**A. ADMINISTRATIVE REPORT & DECISION**

**Project Name:**        Seattle Pipe Trades Expansion

**File Number:**         LUA15-000344, ECF, SA-A

**Project Summary:**    The applicant is requesting Environmental (SEPA) Review and Administrative Site Plan Review for a two-story, 11,885 square foot, building addition and parking lot expansion of the existing two-story building where Seattle Area Pipe Trades and UA Local 32 are located. The existing 243,017 square foot (5.53-acre) site would expand approximately 21,500 square feet to the south through a lot line adjustment with abutting property PID 2423049123. Both properties are located in the Industrial Medium (IM) zone. Vehicle access to the site is provided by Monster Rd SW through an access easement at the north of the site. Associated improvements are relocation of private utilities where the addition is proposed and parking lot landscaping. There are two Category 3 wetlands near the site. The site is located within a floodplain, seismic hazard area, and near steep slopes. The applicant submitted wetlands and biological assessments and geotechnical and drainage reports.

SHEET TITLE / NUMBER  
**PROPOSED  
SITE PLAN**

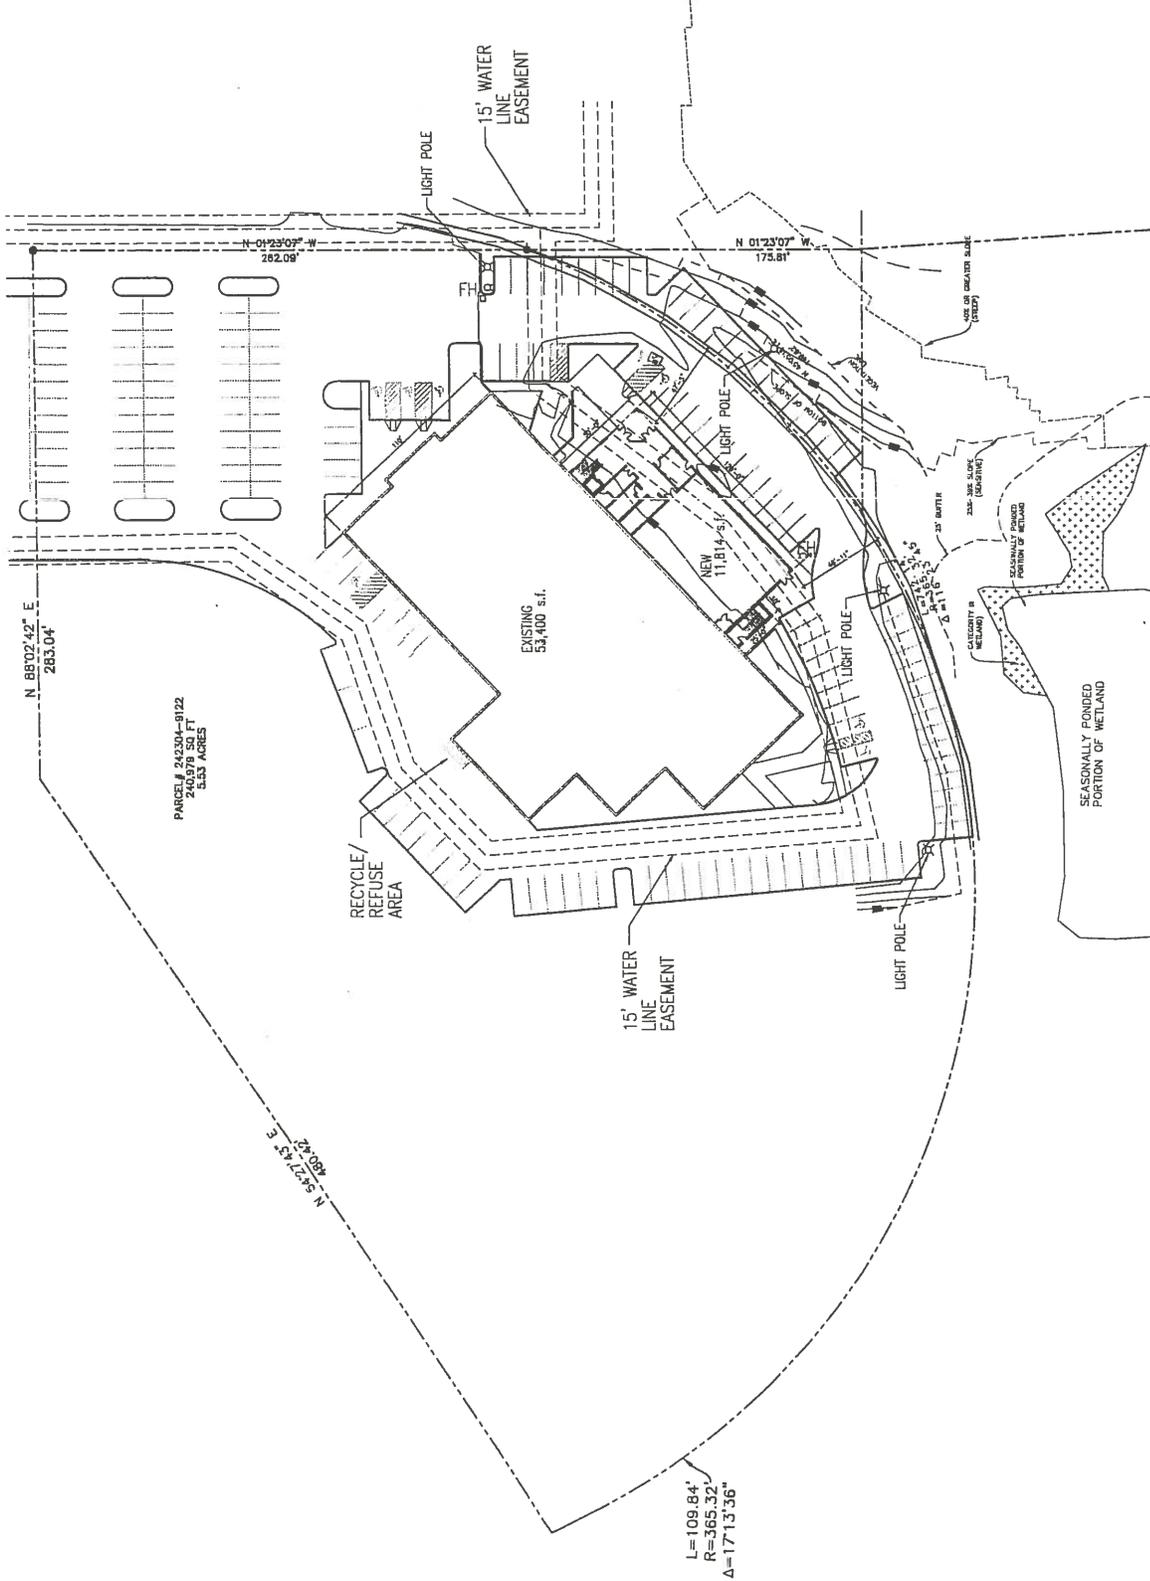
*The proposed building addition will encroach over a portion of the existing 10 inch City water main (refer to attached City water project plan no. W 2193) located within a 15 foot wide easement along the southeasterly side of the property. The applicant shall relocate a portion of the existing water line and related fire hydrants to an alternate location that is acceptable to the City and shall provide the City with a new 15 foot wide utility easement for the relocated water line. The conceptual water plan provided with the land use application shows the water line relocated outside the proposed building. The new water line and related hydrants must be operational before the abandonment of the portion of the existing line. An application to the City for a partial release of the existing easement will be required.*

*Sewer service is provided by the City of Renton. The existing private sewer main under the proposed building extension must be abandoned and the sewer connection should be provided by means of a side sewer to the building with a clean out located within 5 feet of the new building foot print. There are existing easements and utility lines throughout the property which are required to be protected, unless allowed to be relocated by the utility provider. Show the existing and proposed public and private utility lines and easements clearly in the plans provided with the utility construction permit.*

The Seattle Pipe Trades Expansion Site Plan Review Application, File No. LUA15-000344, ECF, SA-A, as depicted in Exhibit 6, is approved and is subject to the following conditions:

1. The applicant shall apply for and record an approved lot line adjustment prior to building permit issuance.
2. The applicant shall provide a detailed landscape plan that provides a minimum of one shrub for each 20 square feet of interior parking area landscaping and that all stalls be within 50 feet distance of in the proposed area of work, to be submitted to the Current Planning Project Manager for review and approval prior to issuance of the construction permit. Additionally, up to 50 percent of the shrubs may be deciduous.
